Access Compliance Report

Public Rights-of-Way

(Curb Ramps)

| Intersection ID: 31934 | Main Street: STEELE_CREEK_RD | Cross Street: BRANCH_BEND_LN | Location: NE |

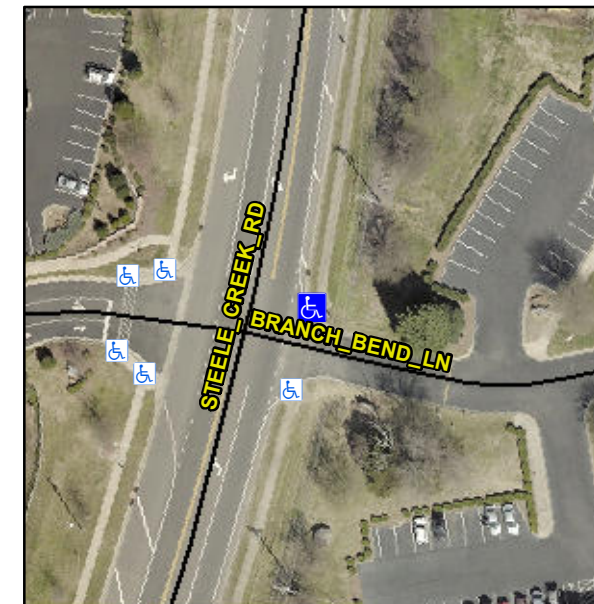
| ADA ID: 76FFD4190D59 | Ramp Type: PerpDiag | Initial Pass/Fail: Fail | Overall Compliance: No |

Not Found, R304.5.1, R304.5.3

| Compliance | Description | Data | Compliance | Description | Data |
|------------|-----------------------|-------|------------|-----------------------------|-------|
| No | Ramp Width (in) | 28.0 | No | Ramp XSlope (%) | 7.2 |

Remove & Replace Curb Ramp With Two New Directional Ramps or Equivalent.
